MONTGOMERY COUNTY HISTORIC PRESERVATION COMMISSION
STAFF REPORT

Address:	5904 Cedar Parkway, Chevy Chase	Meeting Date:	9/11/2019
Resource:	Outstanding Resource Chevy Chase Village Historic District	Report Date:	9/4/2019
Applicant:	David O'Neil & Laura Billings (David Jones, Architect)	Public Notice:	8/28/2019
Review:	HAWP	Tax Credit:	Partial
Case Number:	35/13-19KK REVISION	Staff:	Dan Bruechert
Proposal:	Alterations and New Construction

2 NORTH ELEVATION
SCALE 1/4"=1'-0"

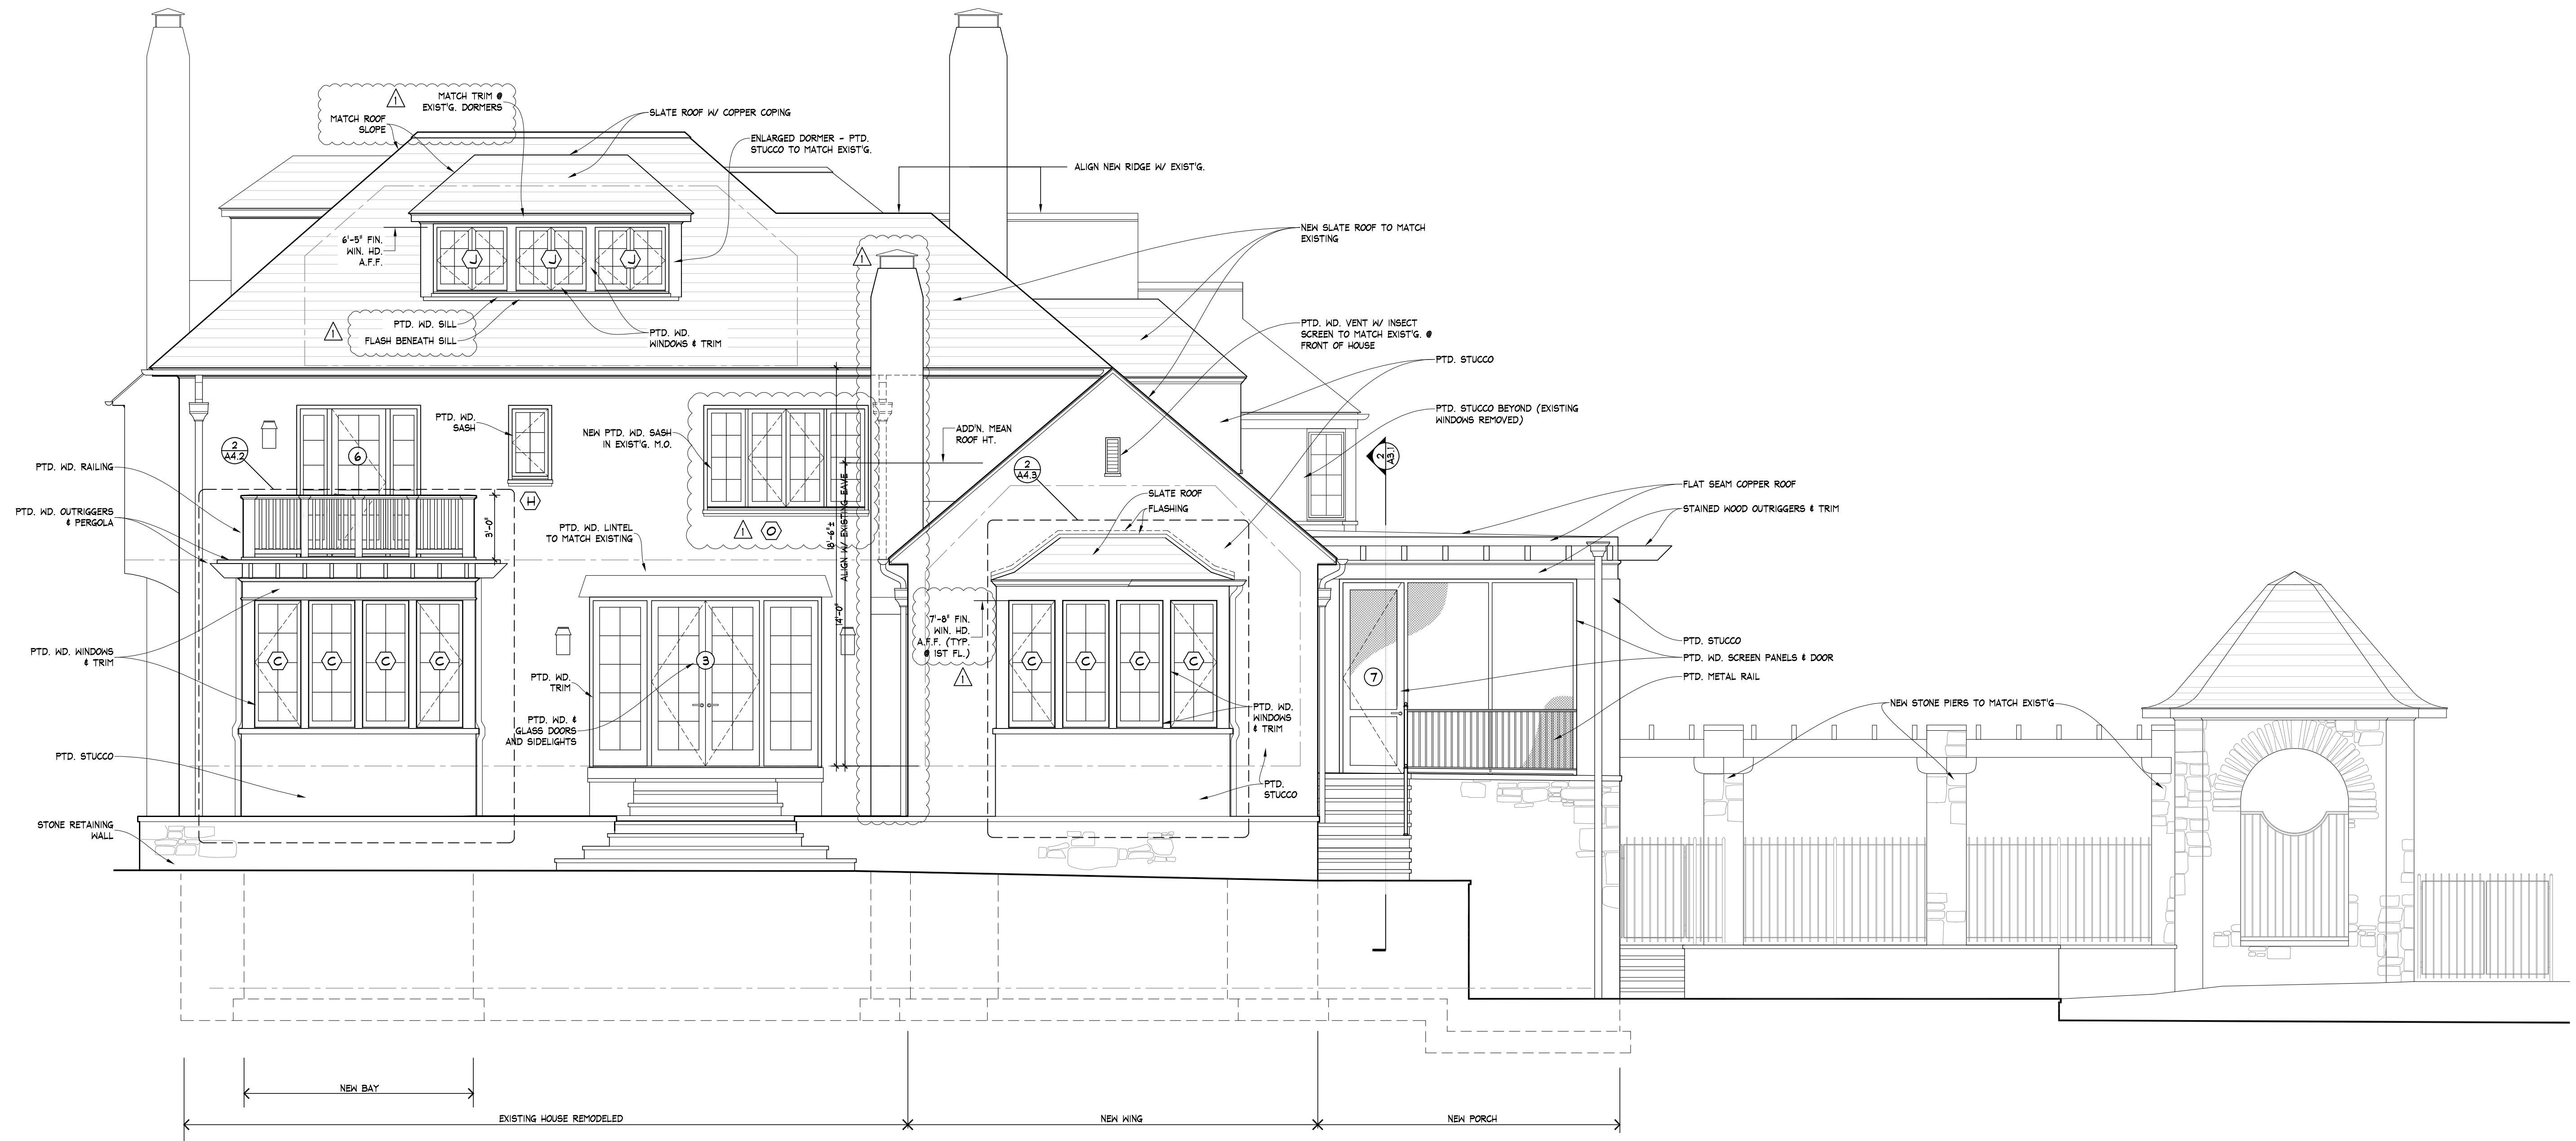
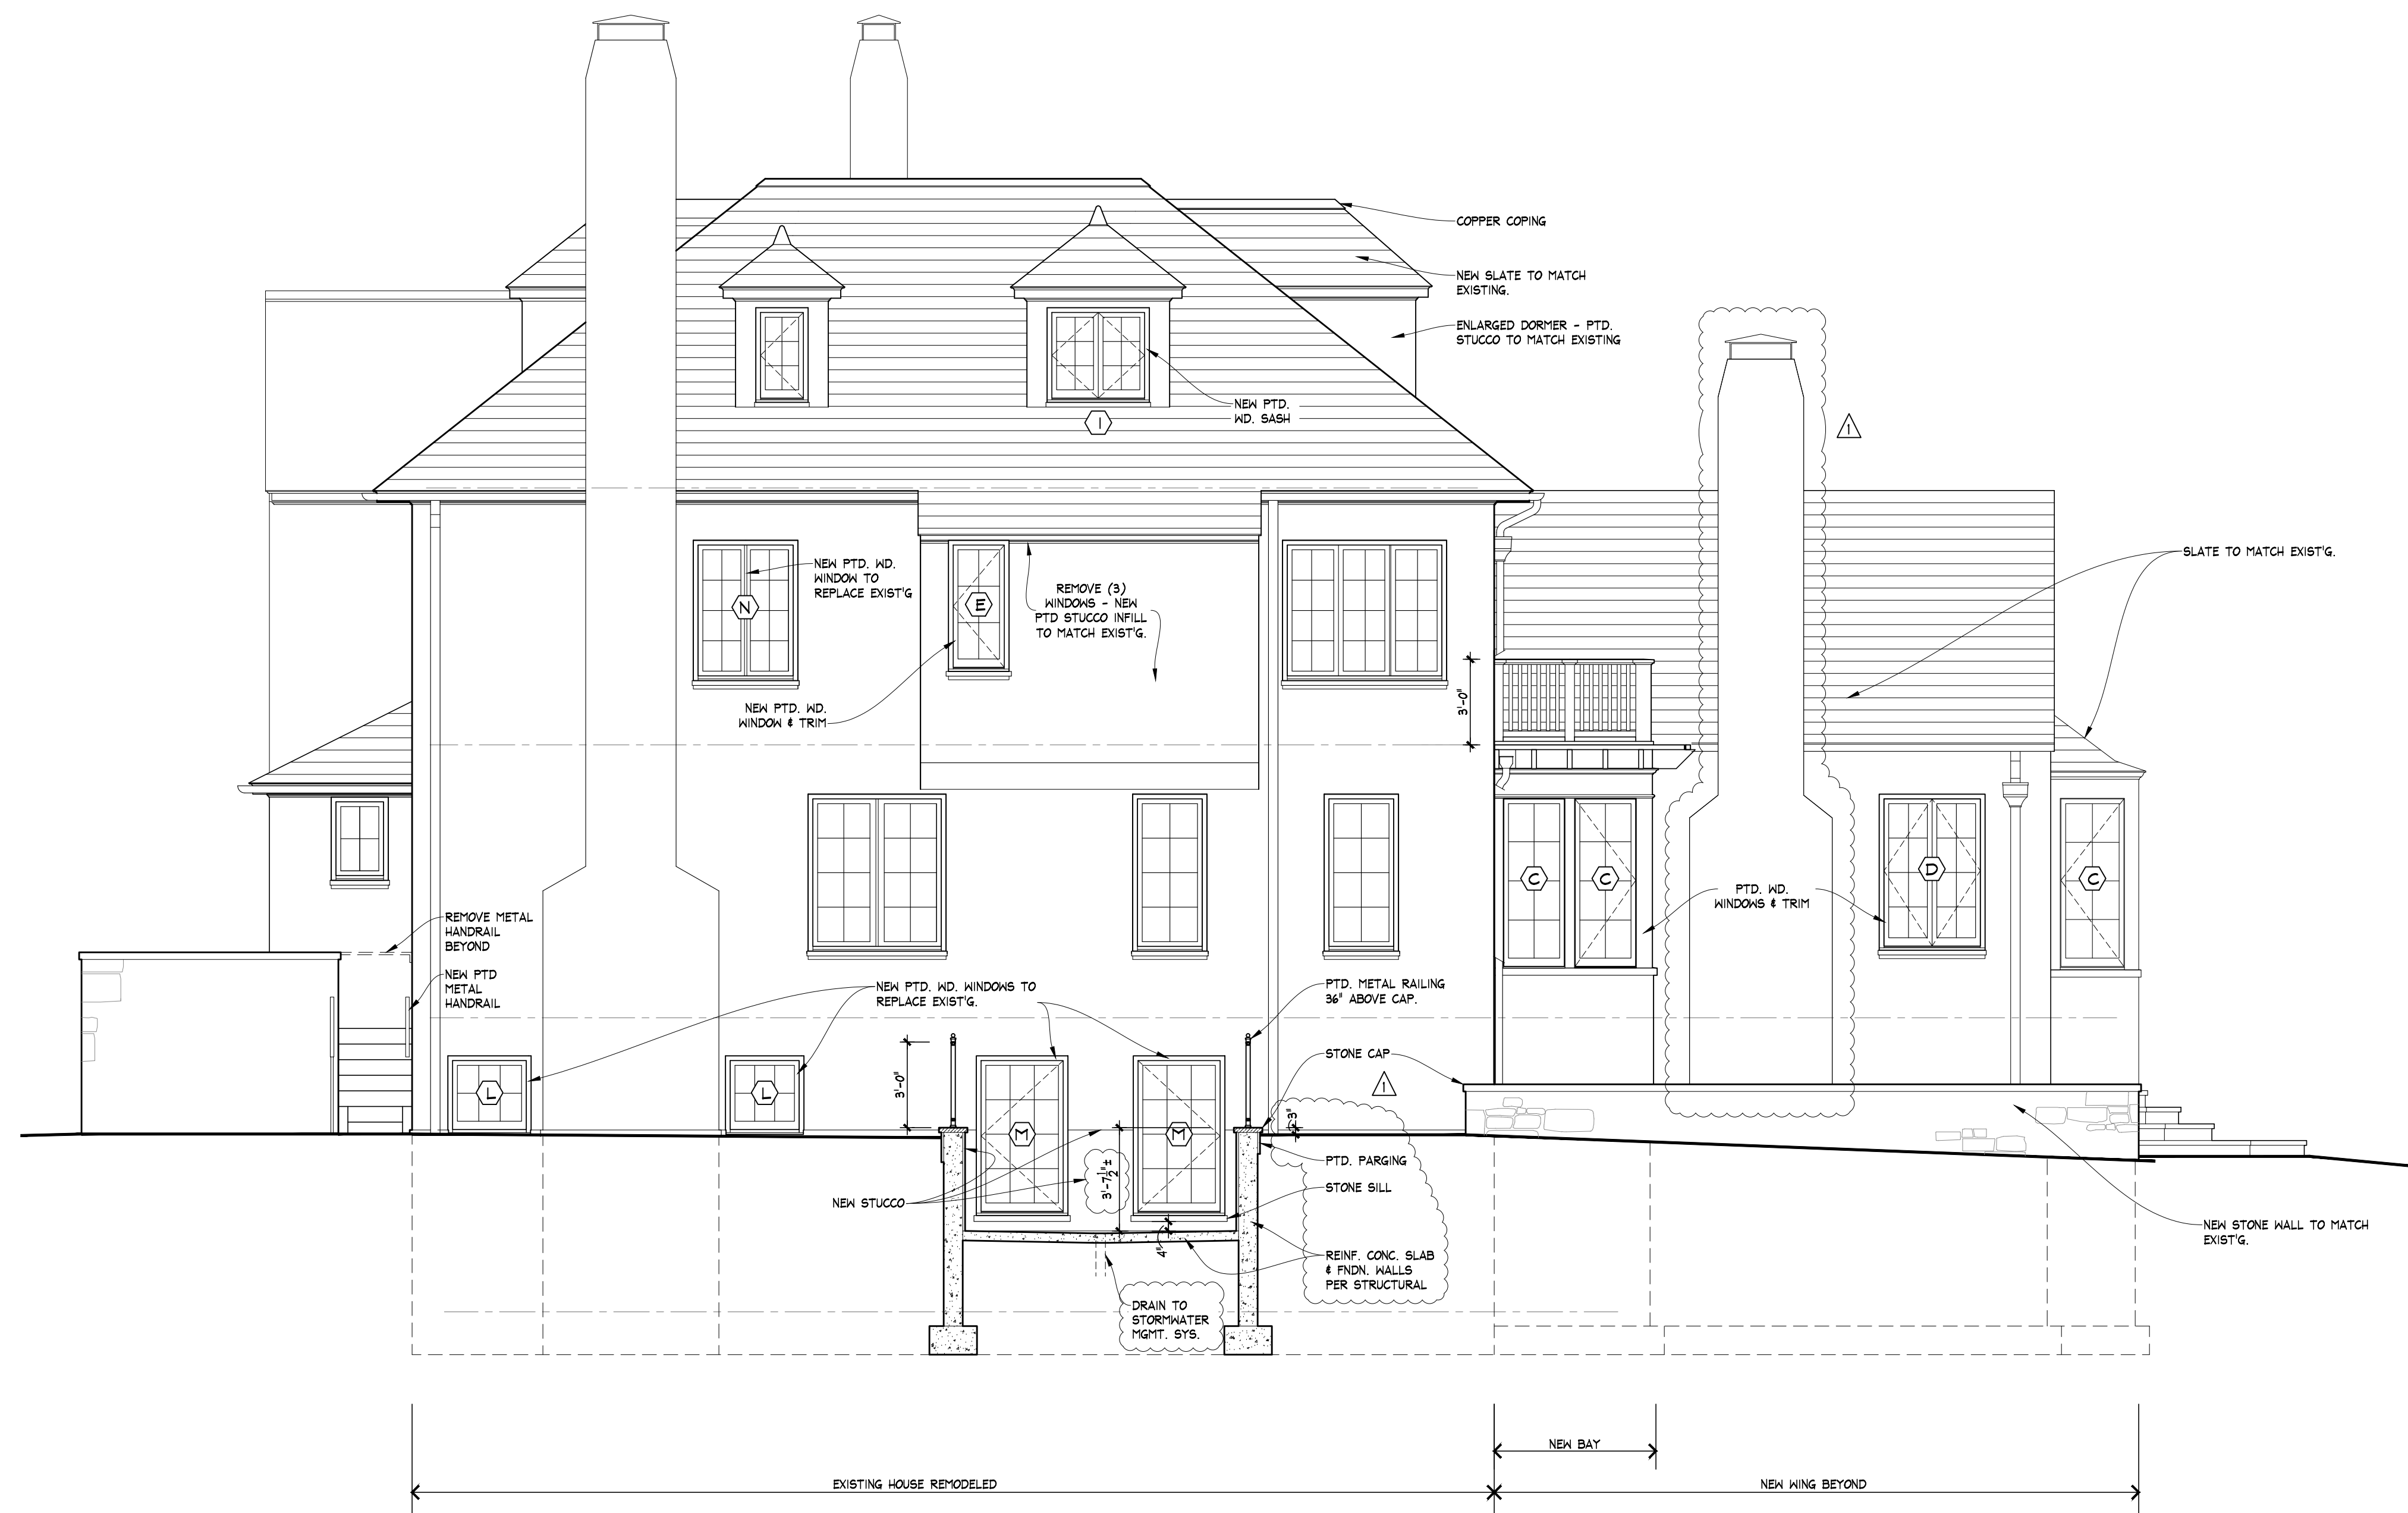
The applicant proposes installing a chimney on the north elevation of the rear addition that was approved as part of the previous HAWP in September 2018. The chimney will be approximately 26' (twenty-six feet) tall and covered in stucco to match the exterior of the house and addition. Staff finds that the exterior treatment of the chimney is compatible with the historic house (24A-8(b)(2)). Due to the massing of the house and the placement of the chimney at the north side of the rear addition, Staff finds that the proposed chimney will not be visible from the public right-of-way. Staff finds that the chimney is appropriate under Chapter 24A and the *Design Guidelines*, which state, "Alterations to the portion of a property that are not visible from the public-right-of-way should be subject to a very lenient review. Most changes to the rear of the properties should be approved as a matter of course." Staff recommends approval of the proposed chimney.
